T.I. No.: 2021-20 Updated: -	Topic: Schaerer Barista - Software-Version 2.4.3
--	---

Date: 02.07.2021	Priority	Need for action
Affected machines: Schaerer Barista	High	As soon as possible
From serial number: -	X Medium	X On next visit to the machine
As of date: immediately	Low	FYI

REASON FOR CHANGES COMPARED TO VERSION 2.4.2

Antifreeze protection / transport preparation

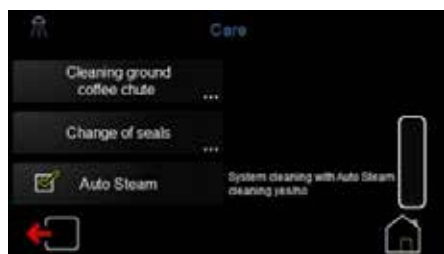
In order to prepare machines that have already been put into operation for transport to another location freeze-proof, an emptying routine has been implemented. This routine is completely display-guided and can only be started when the machine is heated up. As the routine also empties the machine backwards in the direction of the water supply, it is important to disconnect the machine from the water supply - AFTER DISPLAY PROMPT.

After completion of the routine, the machine switches off. In order to make the machine freeze-proof, the steam boiler was emptied by approx. 90% and the steam and coffee paths were blown free via the air pump.

If the machine is switched on again, the system is refilled.

Service > Service routines > Antifreeze protection/transport preparation

2nd Auto Steam and foam pre-selection

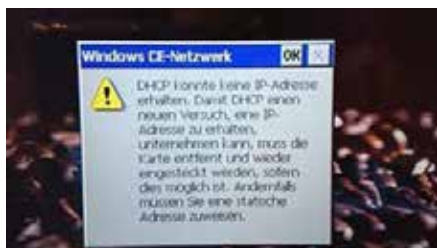
After the feature "Auto Steam pre-selection for machines with two Auto Steam wands" was introduced with software version 2.3.1, we received reports of machines that rebooted during the automatic start of the pre-selected Auto Steam. This error behaviour only occurred when the right Auto Steam was started first and the left Auto Steam waited in the preselection and then started.

The error has been corrected with this software version.
